**1931 2ND AVENUE**

**DESIGN RECOMMENDATION MEETING**

DPD PROJECT #: 3007606

JULY 22, 2008

PLANS FROM EDG #2

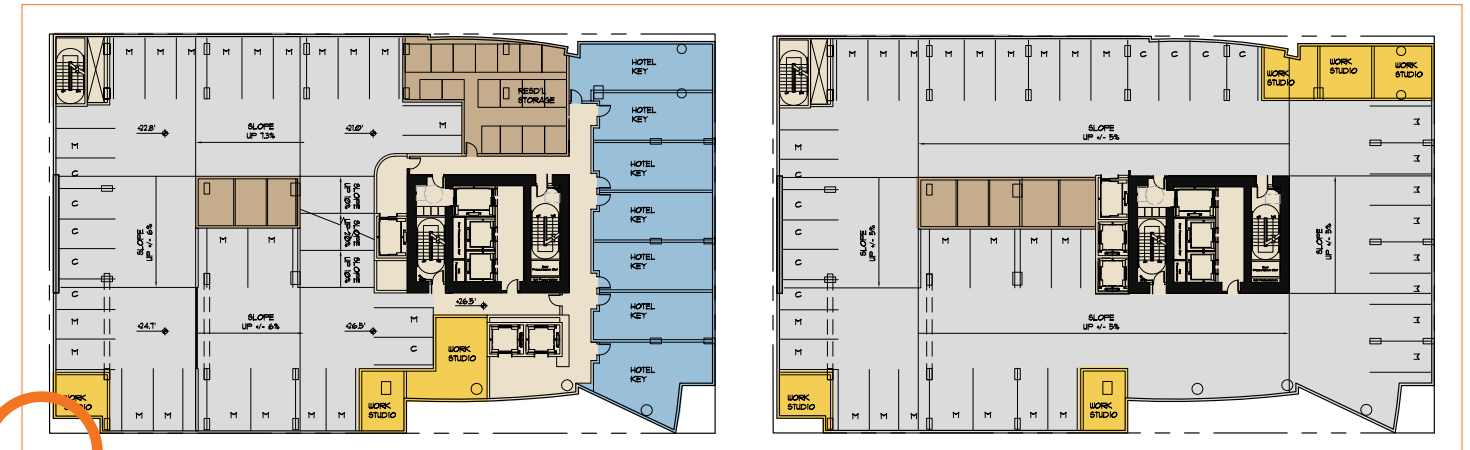
In the preferred scenario, the tower of the south site was moved eight feet from the north property line. The applicant explained that greater than eight feet would necessitate full plate parking which was undesirable as it creates frontage of the parking use along Virginia. The Board agreed that screening this façade with active hotel uses is preferable. The top of the tower was modified to step away from Virginia Street, down to adjacent structures and the massing was modified to step down to adjacent structures including OPT. The Board confirmed that the shifting of the tower by eight feet seemed a reasonable and realistic resolution.

The Board strongly agreed that the design of the two buildings should steer away from concepts or designs that are similar to each other. The two towers will appear as a pair from and that alone is a sufficient commonality. The Board encouraged different building profiles that will read from a distance.

PLAN FROM EDG #2

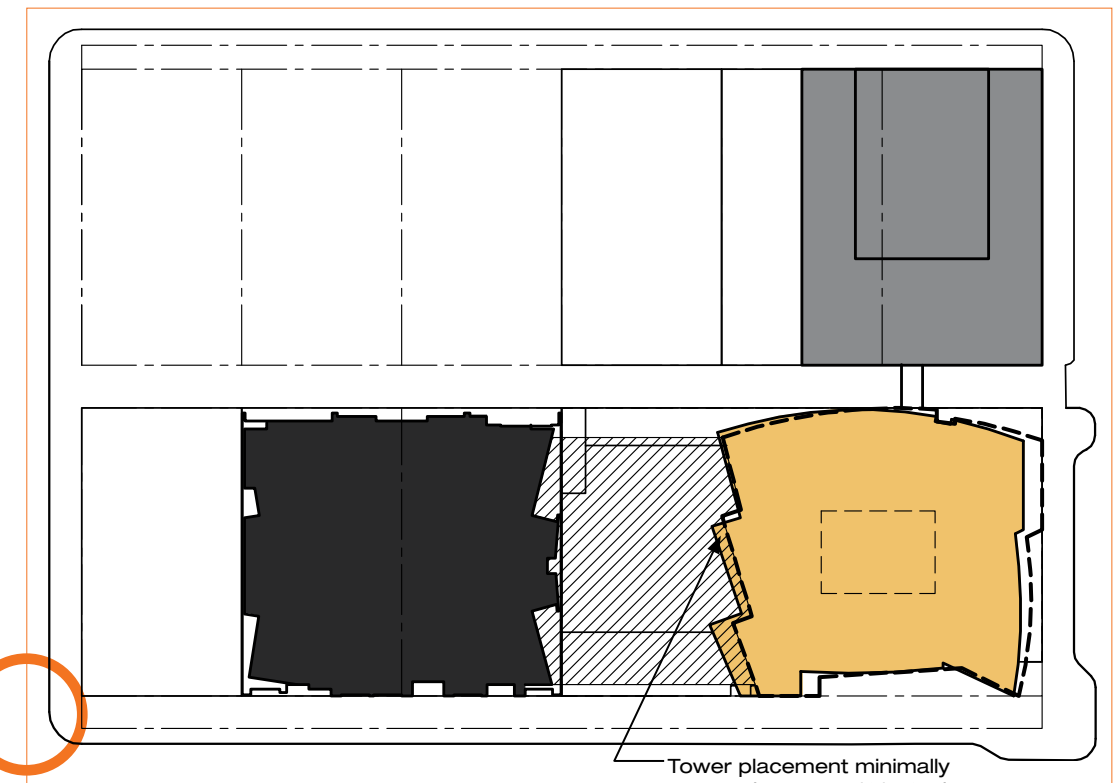
The Board was satisfied that the explorations of distances between the two buildings were well analyzed and they agreed with the preferred option.

For both buildings, the Board would like to see more integration of the base design into the tower. The Board looks forward to reviewing three-dimensional images of the podium and tower designs and how they relate.

Tower placement minimally encroaches upon 1915 2nd Avenue.

PREFERRED OPTION PLAN

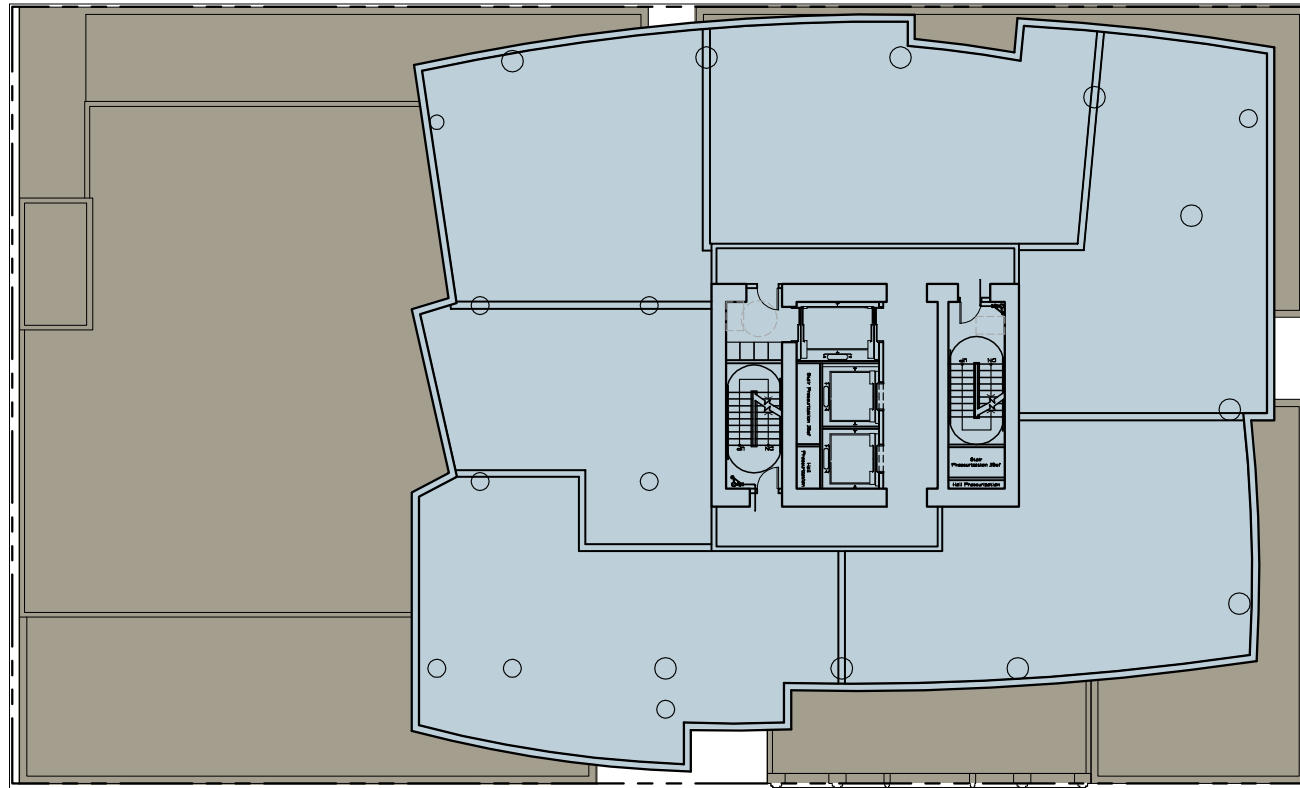
- The new corner building element should approximate the height of the Terminal Sales Annex and should be held out to the Second Avenue property line to be flush with the Terminal Sales Annex. Base C “Medium Corner” concept was preferred.

- The glass curtainwall can extend down from the tower to the south of the Terminal Sales Annex, as it provides a nice transition to the building element to the south and creates a nice recessed entry.

- The building element south of the curtainwall adjacent to Second Avenue could be of a lower height than the Terminal Sales Annex and new corner building element.

- The north elevation façade provides a nice transition from the height of the TSA to the height of the Terminal Sales Building across the alley. The glass element extending down from the tower between the tall and the shorter facades was desirable.

- Canopies should not be placed on the TSA building and canopies on each side should stop not less than two feet from the TSA.

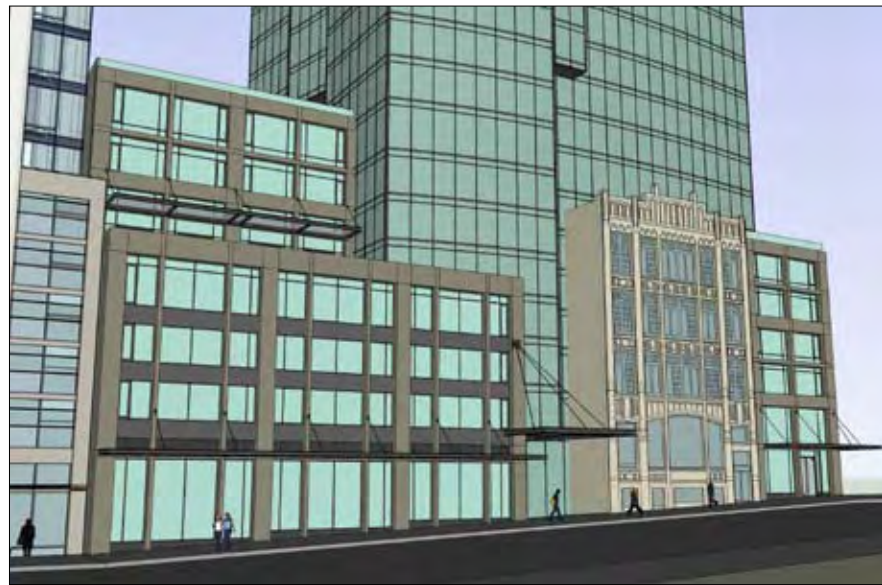
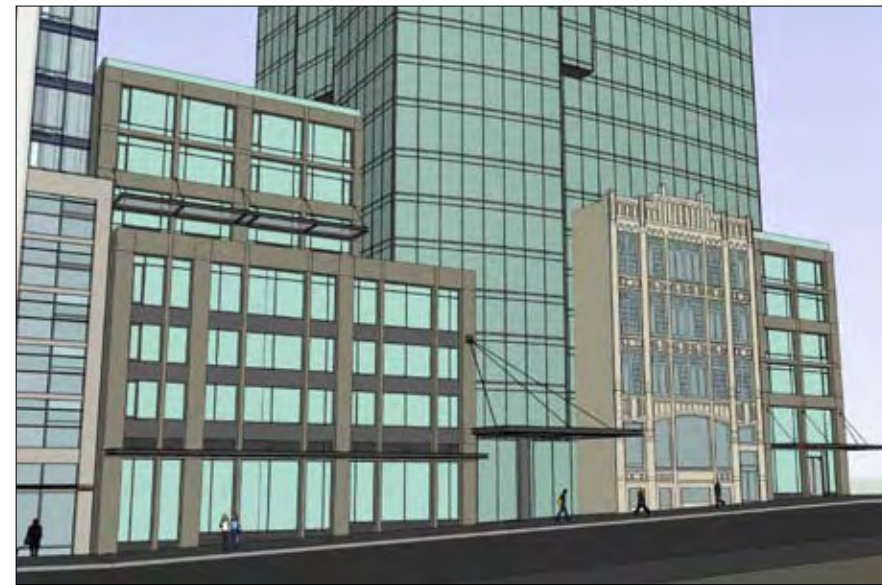
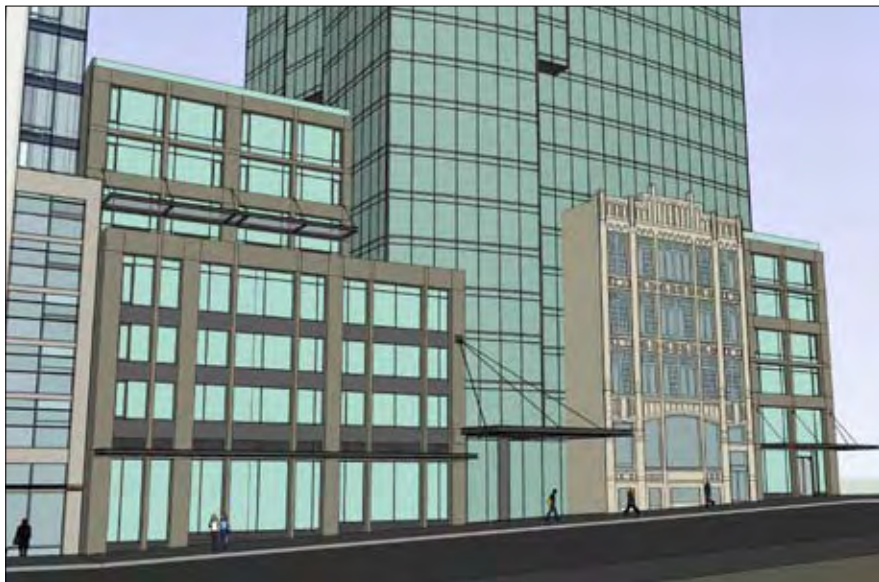
- The committee felt the design was almost there, and not requiring major shifts in design.
- The committee supported the relationships made between our base elements and the Terminal Sales Building and Annex (TSA).
- The committee supported the simplicity and restraint provided by the architecture of the base elements.
- There were two concerns about the relationship of the hotel entrance on 2nd Avenue and the TSA.
  - A. The applicant was urged to find a solution that exposed more of the south facade of the TSA similar to the setback expressed by the tower element above the TSA.
  - B. The applicant was urged to explore an alternate to the glass tower “hyphen” at the hotel entry, possibly a more solid “construct” hyphen element.
- The applicant was asked to explore and present multiple options to discuss at the next meeting

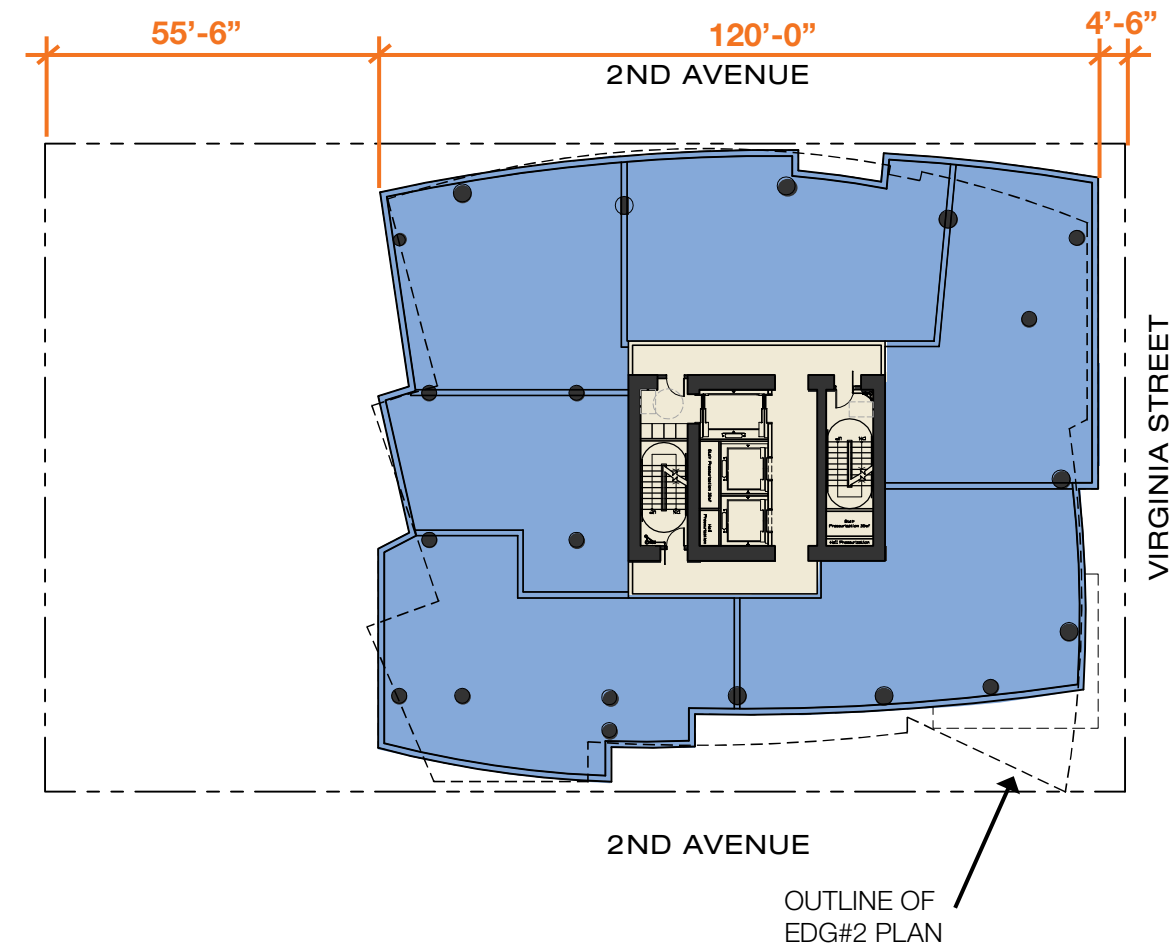
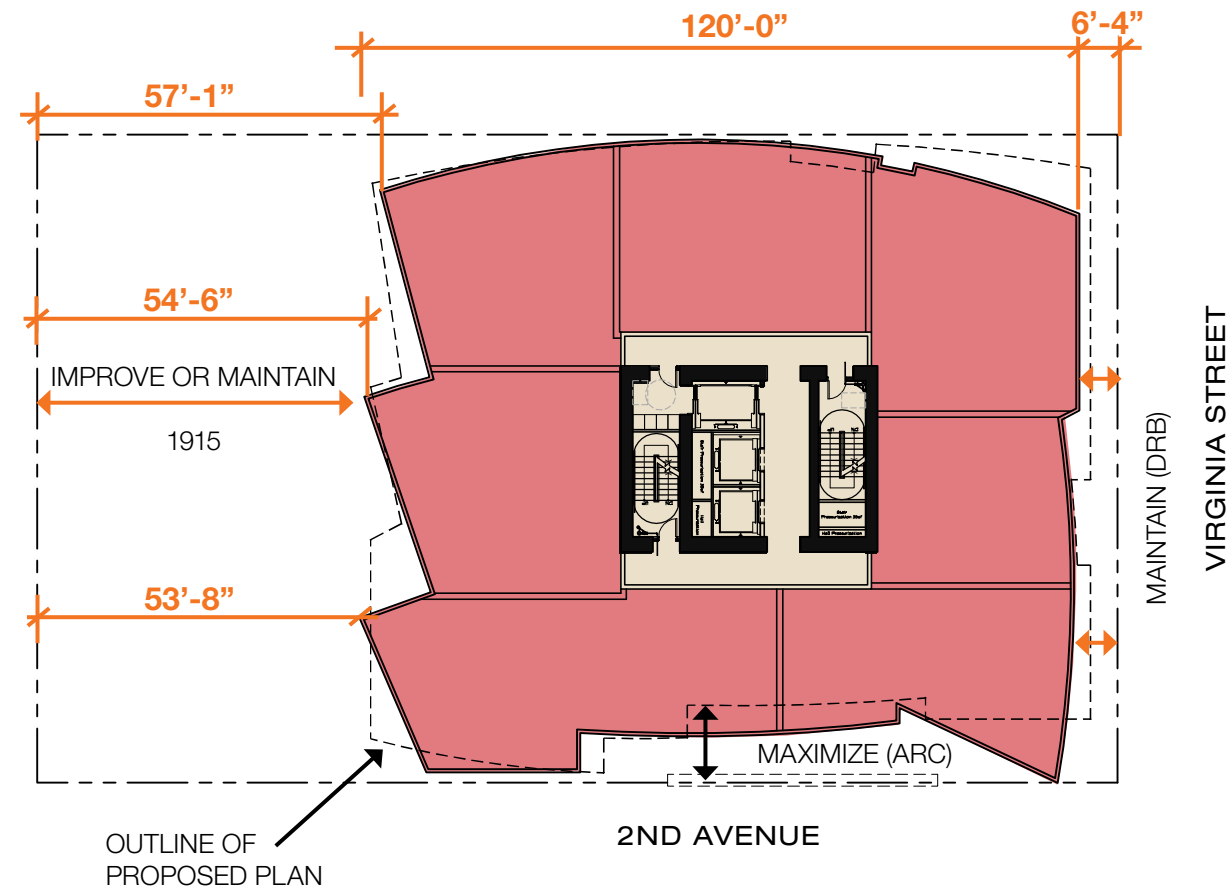
- The committee rejected both option #4 and #5 as too busy, and not in character with the other facade treatments.
- The committee reiterated it's support for the subdued architectural expression for the rest of the base.

- The committee largely preferred the base of option 1, maintaining the 3 bay parking structure element. This was seen to relate somewhat to the tri-partite base elements on the TSA facade.

- Some interest was shown for the 2-1/2 bay base in option #3 but that interest was deferred to the architects to choose what was best for the building.

- The committee largely preferred the tower of option 3, which moved 2 tower massing elements 5' south.
- The committee would like further exploration of any possible ways to physically or otherwise expose the south wall of the TSA more. Options include moving the glass plane back at the "hyphen" or exposing the wall through the clear glass entry and upper levels as a part of the interior design.

## TYPICAL PROPOSED TOWER PLAN

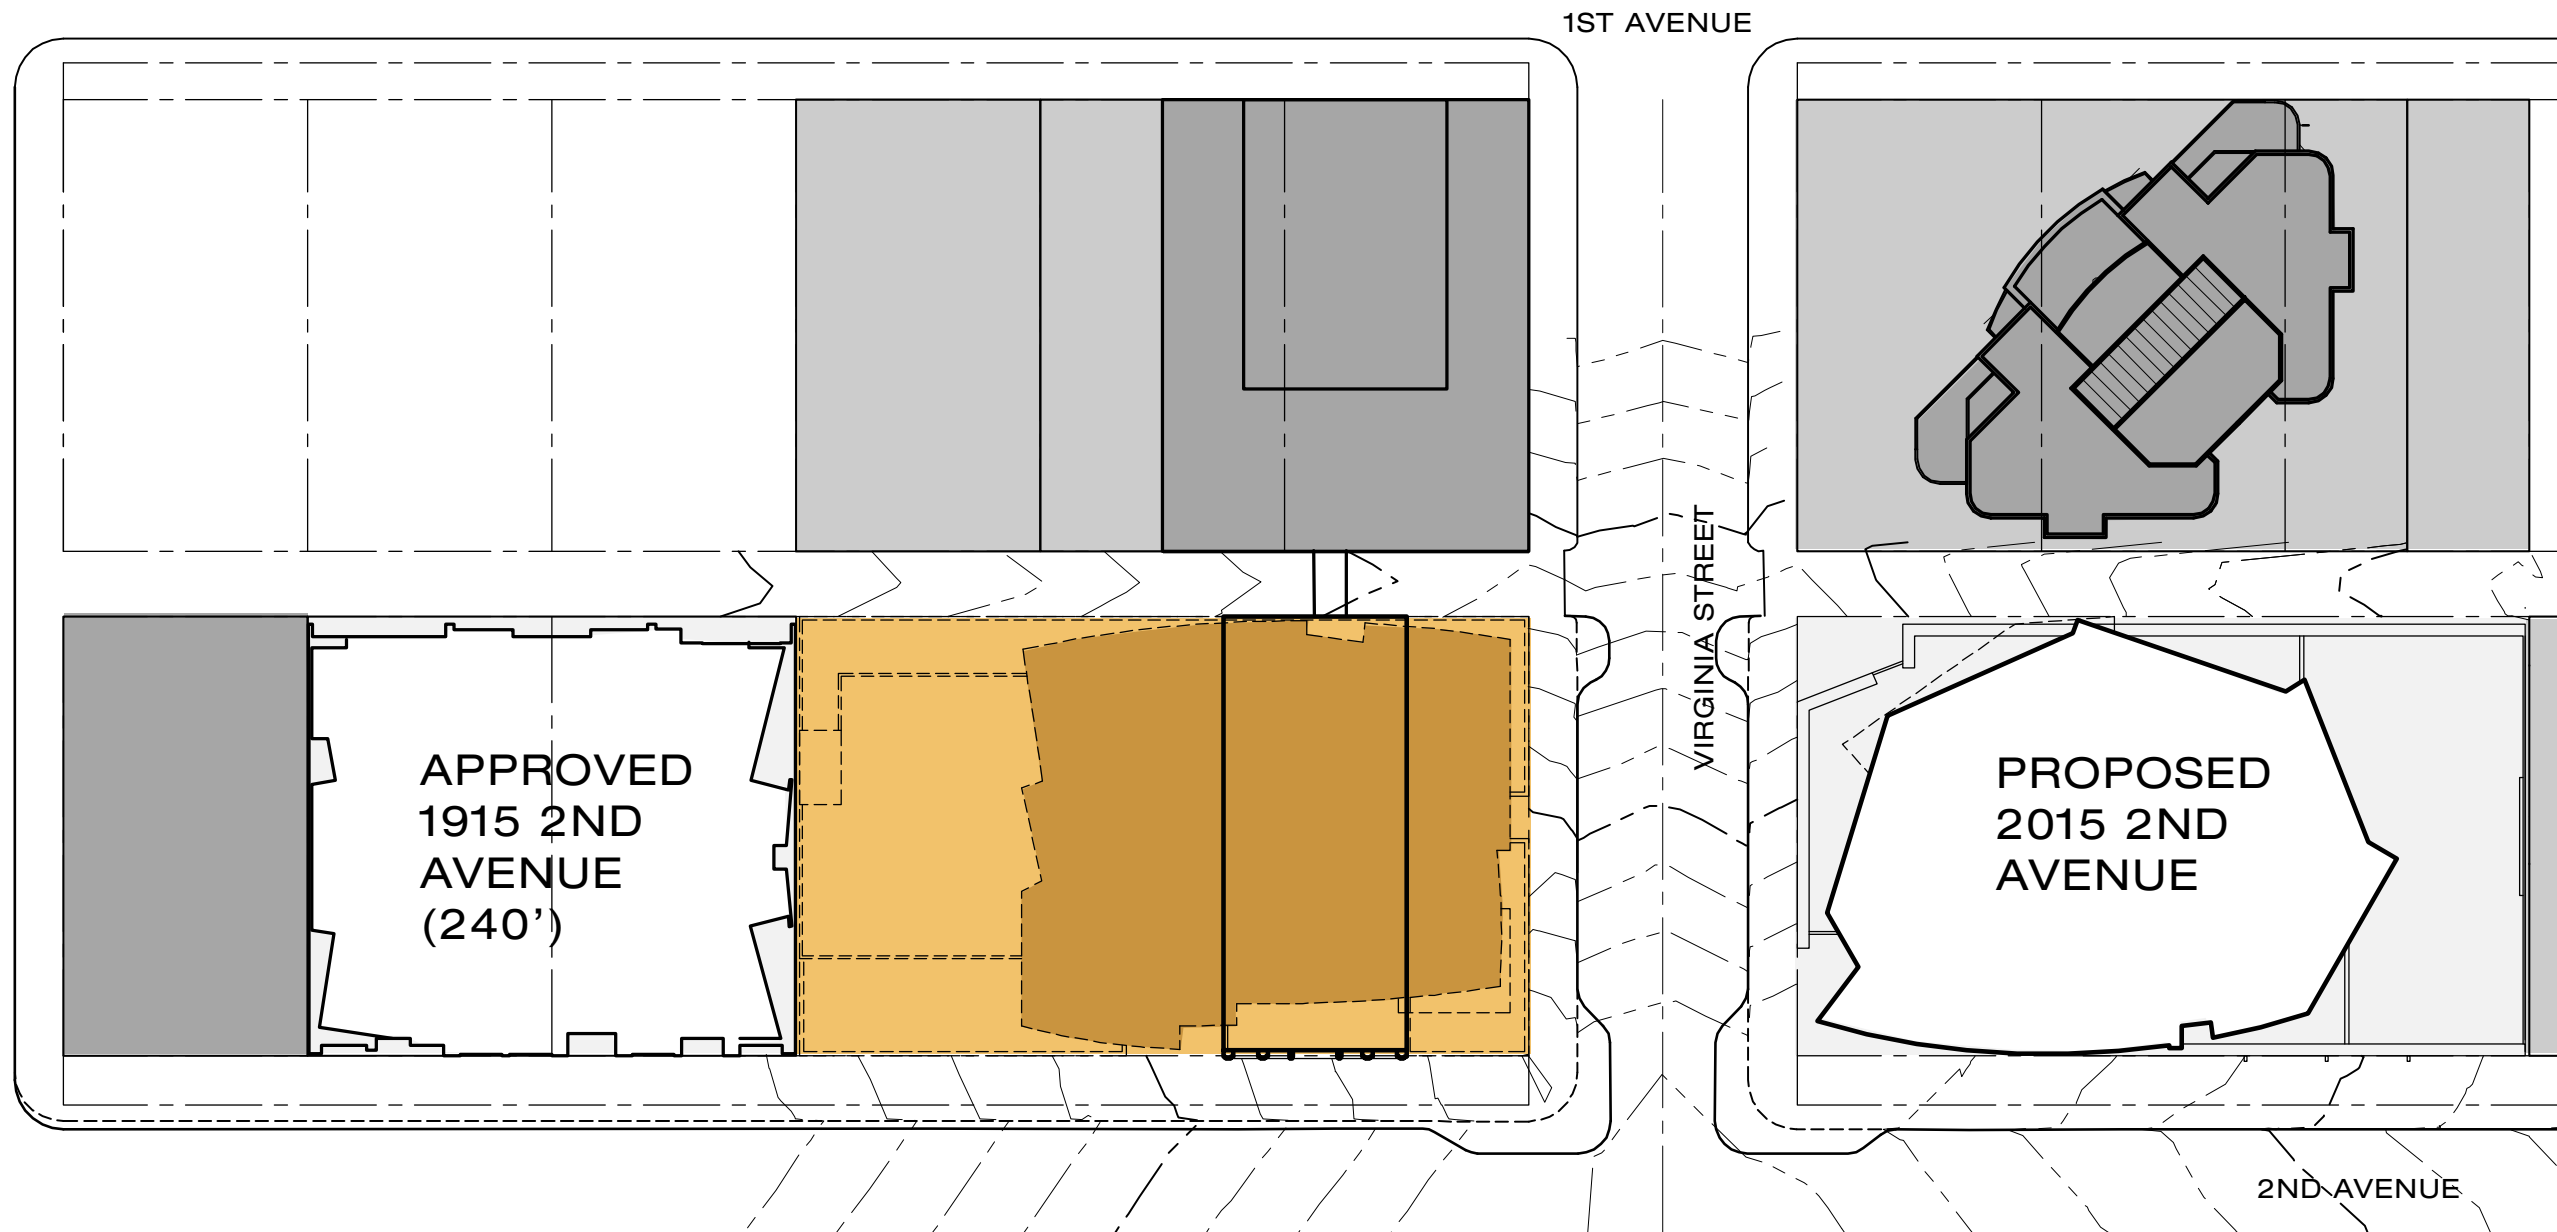
- The Architectural Review Committee (ARC) has directed us to maximize the setback for the tower in order to expose more of the depth of the Terminal Sales Annex (TSA).
- Public comments made in EDG #1, and 2 on behalf of the 1915 project asked the applicant to try to maintain the separation between the two towers.
- At EDG #2, the board asked the applicant to try to maintain or increase the separation of our tower from the Virginia St. property line.

- The design team pushed the East façade back to the furthest extent that we could where the structure would not interfere with below grade parking. This exposes approximately 13'-6" of the south TSA façade. This move initiated some massing changes which include; elimination of the prow form at the corner of 2nd and Virginia, and stripping the east facade of massing depth.

- The design team looked at ways to increase this setback, however, the significant massing change directed by the ARC required that the massing hold firm on this dimension and add sf along this façade.

- The design team looked at ways to maintain or increase this setback, however, the significant massing change directed by the ARC required that the massing add sf along this facade. The setback from property line was reduced by 22 feet. However, the massing significantly steps back from the corner of 2nd and Virginia both in the north-south and east-west direction. This move reduces the perceived impact of the tower at the corner, and opens the corner up for the OPT and 2015 2nd Avenue Projects in terms of light and air.
